## **CENTRAL PRECINCT DETAILED DESIGN SSDA (SSD-10439) - RESPONSE TO REQUEST FOR INFORMATION #2**

This letter provides further response to items 2 and 3 of the Request for Information (RFI) letter prepared by the Department of Planning, Industry, and Environment (DPIE) dated 13 April 2021. This letter provides revised solar amenity information and is supplementary to the first RFI package issued to DPIE on 23 April 2021 for the assessment of SSD 10439, relating to the Waterloo Central Precinct Over Station Development (OSD).

**WEST HIGH RISE APARTMENTS - LEVEL 20 AND 21**

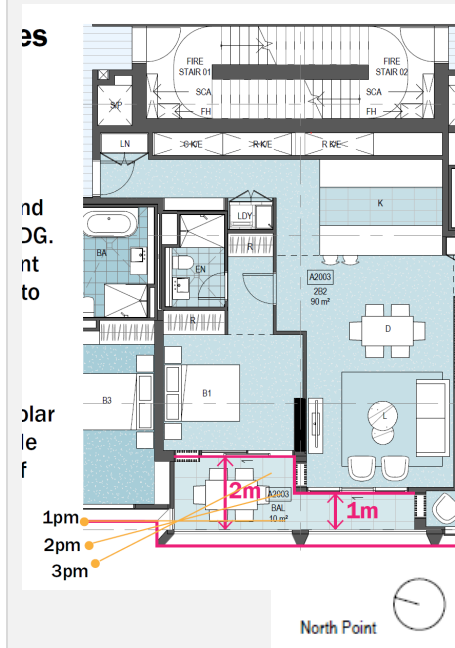
The living room glazing is shifted east by 1m. The bedroom of adjacent apartment to shift east 700mm to allow north facing frontage for the private open space.

Solar is received to the living room from 1.55pm to 3pm, this is an improvement of 20min of solar compared to the original SSDA scheme.

Solar is received to private open space for the full two hours between 1pm to 3pm, this is an improvement of 15min of solar compared to original SSDA scheme.

Living room and private open space both receive 1sqm of solar access for 50min between 2.10pm to 3pm.
